SUBJECT: COMANCHE PEAK STEAM ELECTRIC STATION (CPSES)
DOCKET NOS. 50-445 AND 50-446
REQUEST FOR ADDITIONAL INFORMATION ON RXE-91-002
"REACTIVITY ANOMALY EVENTS METHODOLOGY"

TOPICAL REPORT RXE-91-002

REACTIVITY ANOMALY EVENTS METHODOLOGY

Figure A-1 BOC HFP Core Average Fission Power Response

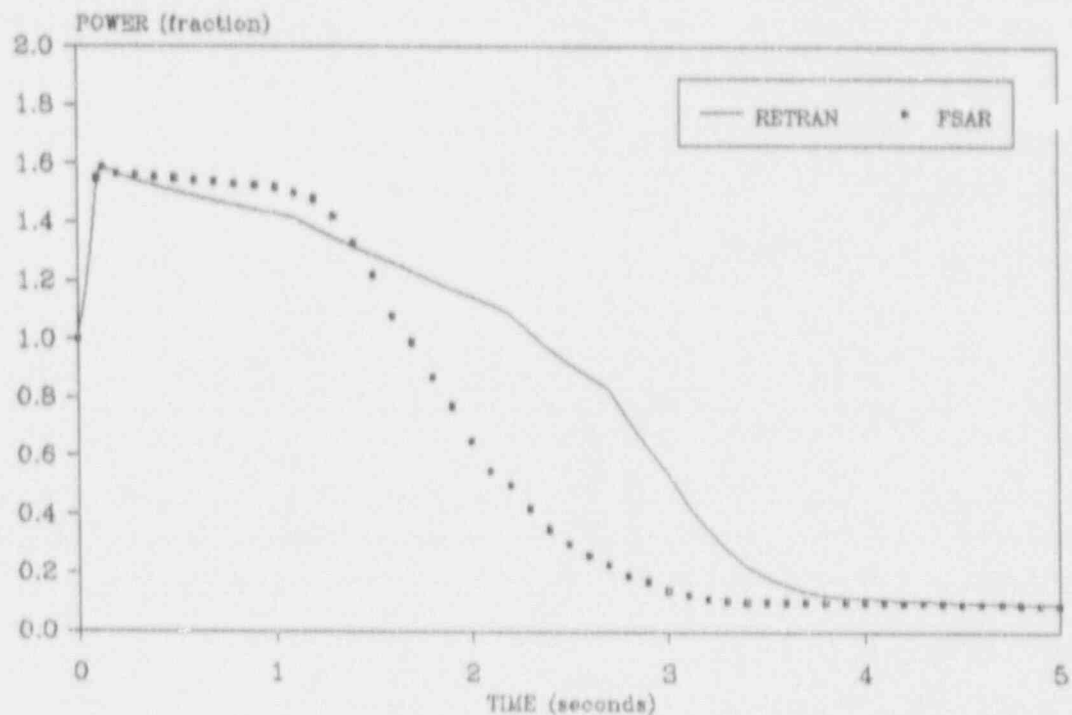
Please demonstrate the conservative nature of TU Electric's point kinetics analytical approach to the Control Rod Ejection (CRE) event by providing a comparison to the current CPSES Unit 1 CRE event analyses.

The calculated power histories for the BOC HFP scenario (Figure A-1) demonstrate that the peak core average fission power predicted by the 1-D and point kinetics models are nearly identical. In addition, the peak power for each model occurs at the same time, as shown in Table A-4. However, two noteworthy differences are evident.

The more significant of the two differences relates to the predicted power history after the release of the control rods following reactor trip signal (~0.35 second). The use of different methods for modelling the reactivity insertion caused by the control rods falling into the core after reactor trip causes the power histories to deviate. The methods employed by the 1-D kinetics model achieve greater accuracy for trip reactivity insertion by crediting the changes in the reactivity insertion rate as a function of the axial flux shape. The point kinetics model, on the other hand, must utilize a fixed table of reactivity versus time to conservatively represent the scram characteristics. This table is based on an axial flux distribution selected to provide a delayed insertion of the trip reactivity.
